MARICOPA COUNTY
Department of Transportation

Date: May 21, 2014
To: MAG Specifications and Details Committee
From: Robert Herz, MCDOT Representative
Subject: Delete the use of Asbestos-Cement Pipe in Valve Box Installations **Case 14-11**

PURPOSE: Delete the use of Asbestos-Cement Pipe in Valve Box Installations.

DETAIL NO.
391-1

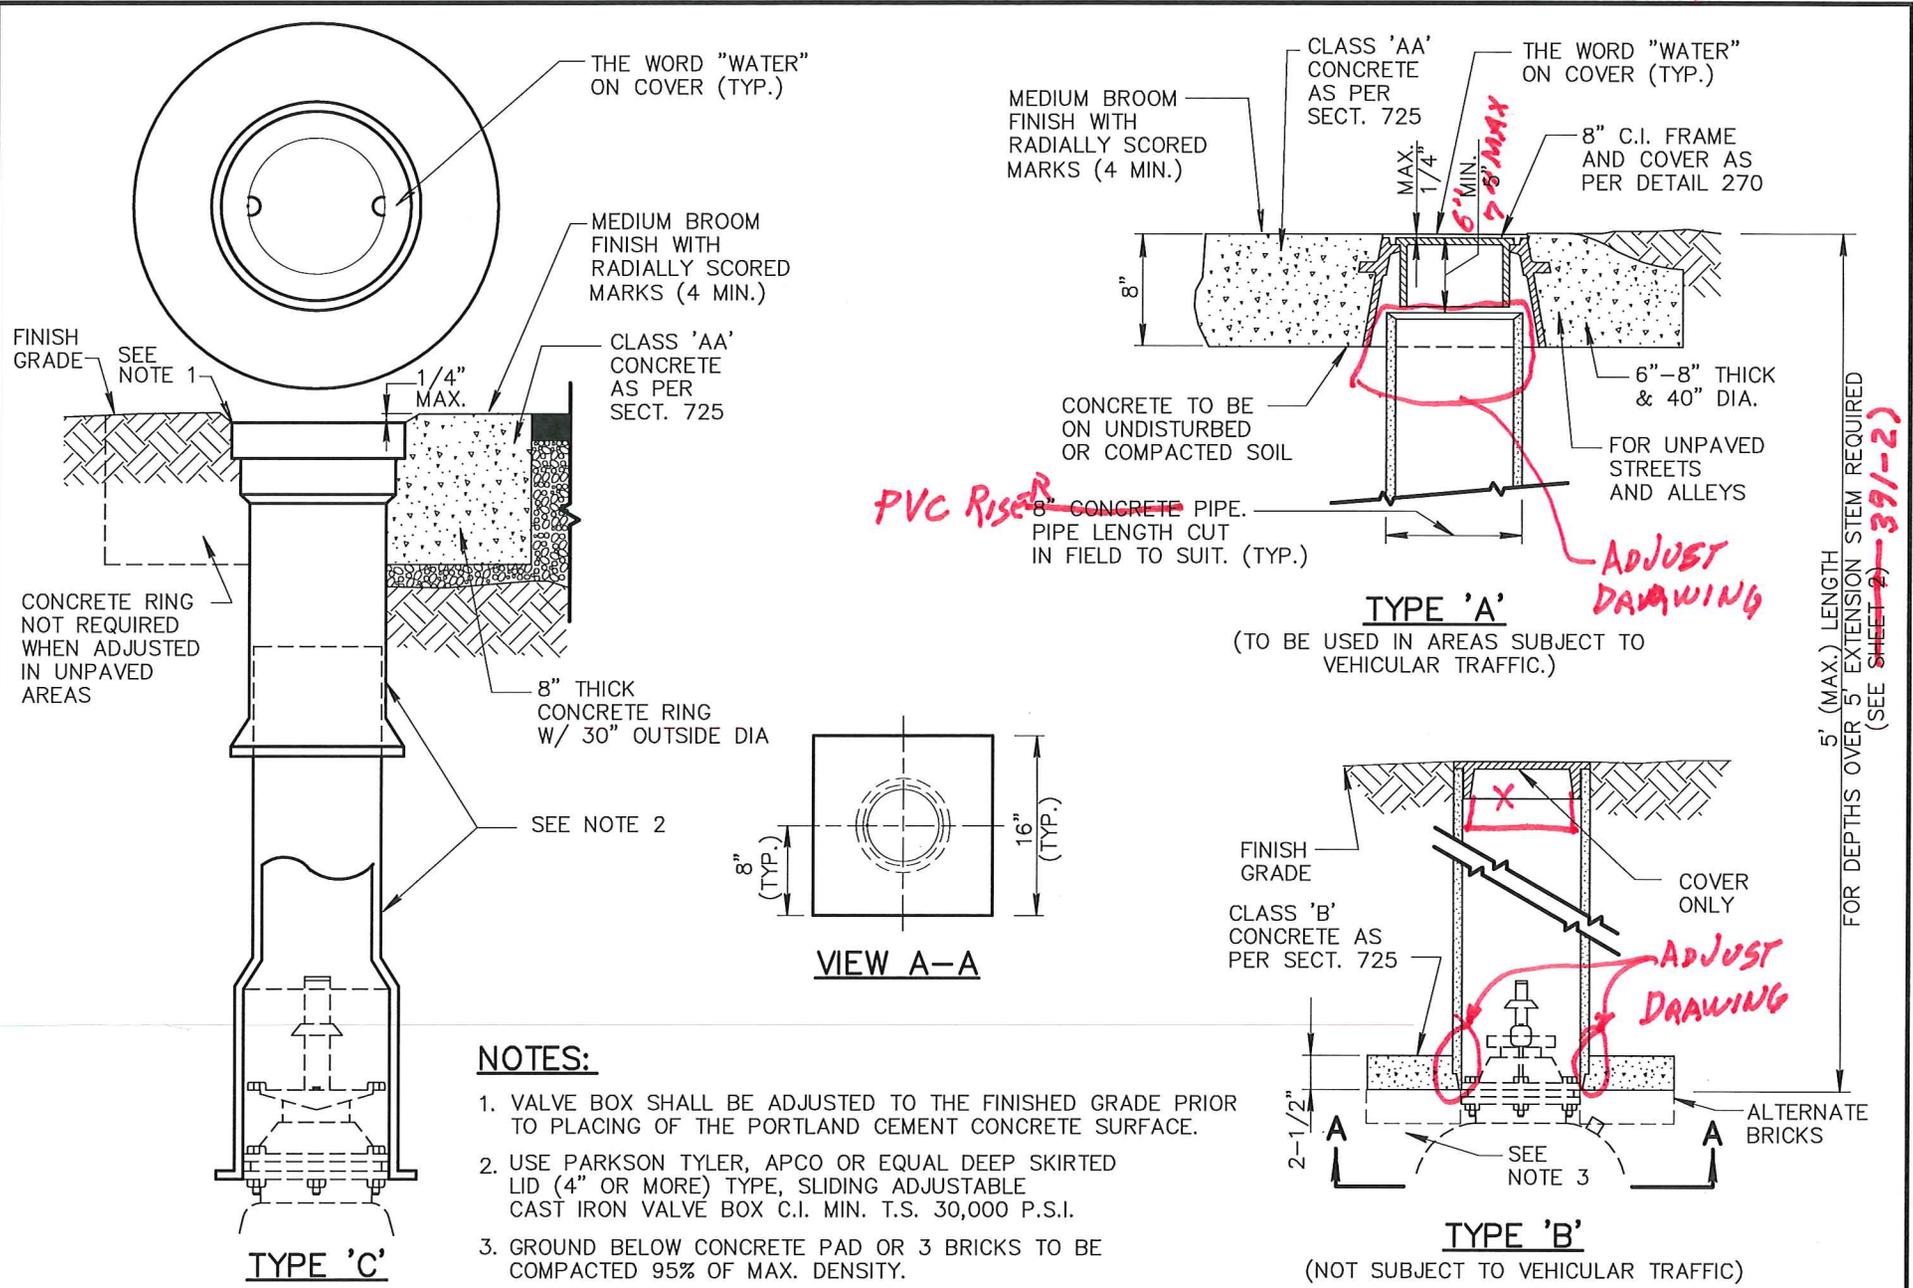
REVISION: Replace ACP with PVC C900 pipe in Detail 391-2 and make associated drawing changes to Details 391-1 and 392. See the attached marked-up drawings. Also revise specification Section 610.7 as needed to accommodate the change. This change is patterned after City of Phoenix Detail P1391.

PVC Riser

ADJUST DRAWING

ADJUST DRAWING

391-1

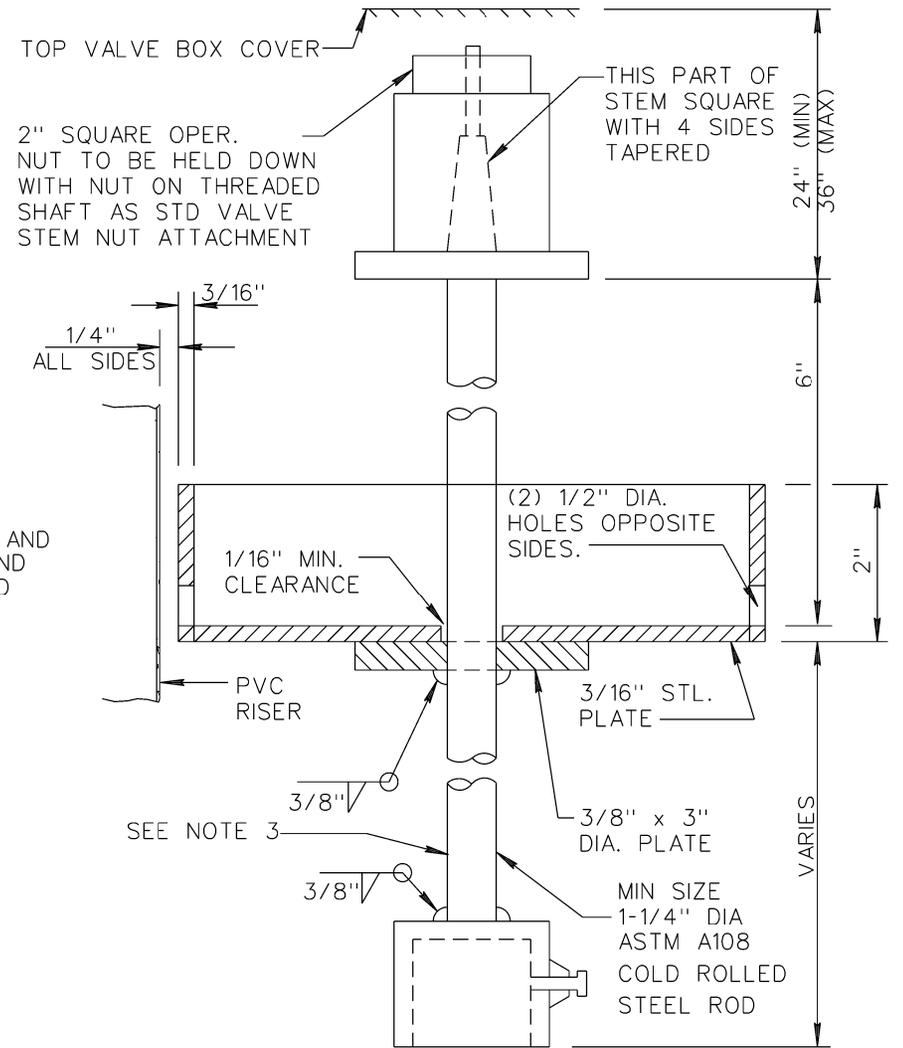
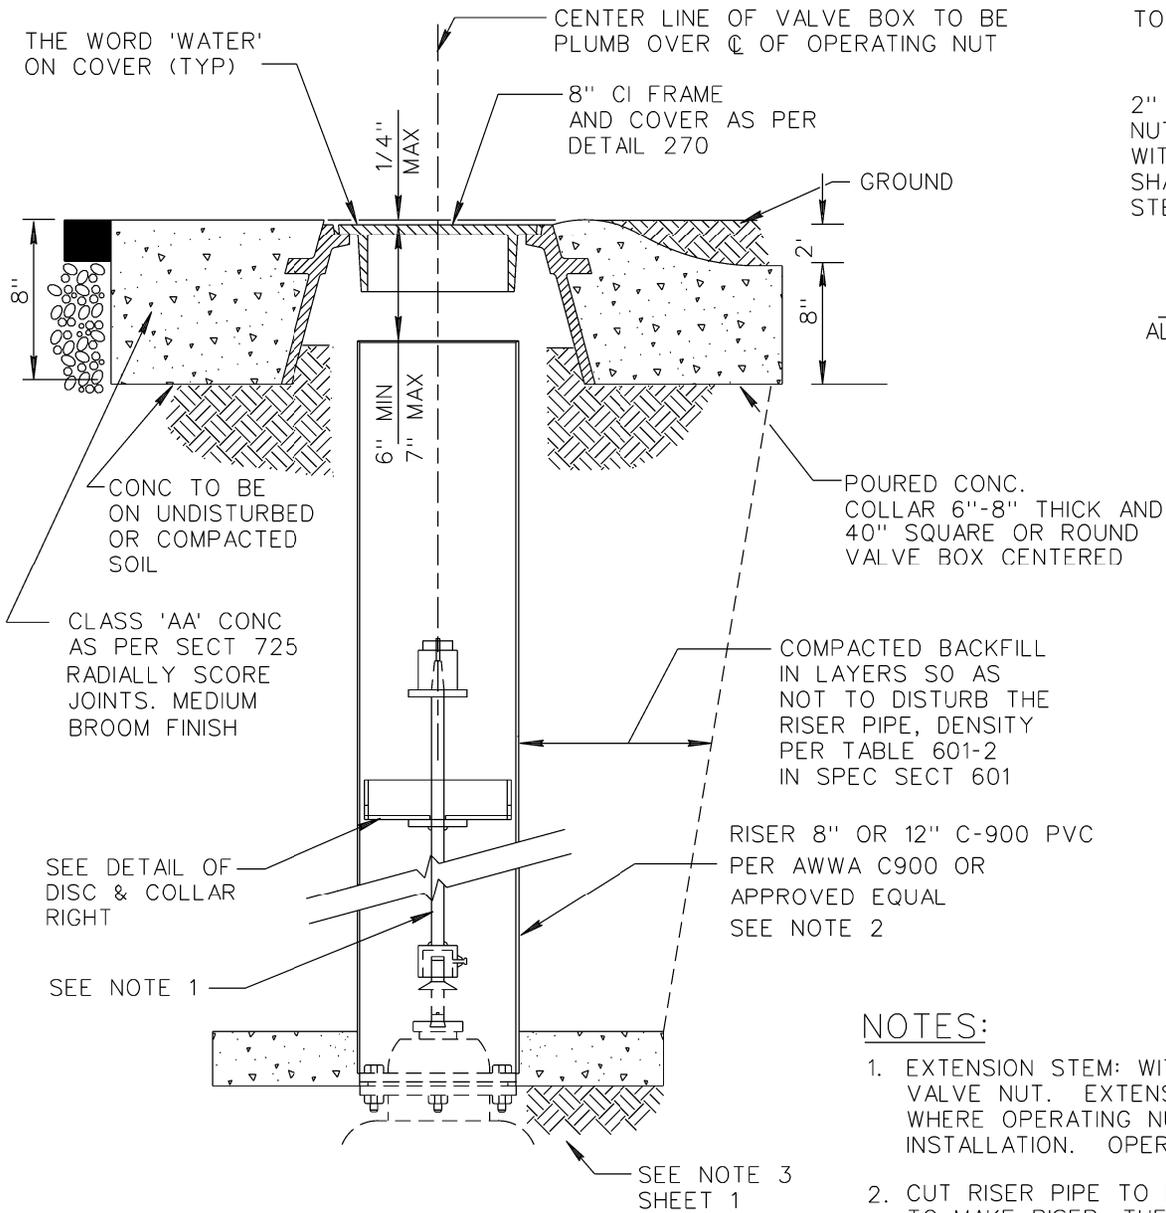
1. VALVE BOX SHALL BE ADJUSTED TO THE FINISHED GRADE PRIOR TO PLACING OF THE PORTLAND CEMENT CONCRETE SURFACE.
2. USE PARKSON TYLER, APCO OR EQUAL DEEP SKIRTED LID (4" OR MORE) TYPE, SLIDING ADJUSTABLE CAST IRON VALVE BOX C.I. MIN. T.S. 30,000 P.S.I.
3. GROUND BELOW CONCRETE PAD TO BE COMPACTED 95% MAXIMUM DENSITY.
4. CUT RISER PIPE TO LENGTH IN FIELD. **CAUTION:** IF EXISTING RISER IS ASBESTOS-CEMENT PIPE (ACP) FOLLOW OSHA GUIDELINES FOR WORKING WITH ACP.
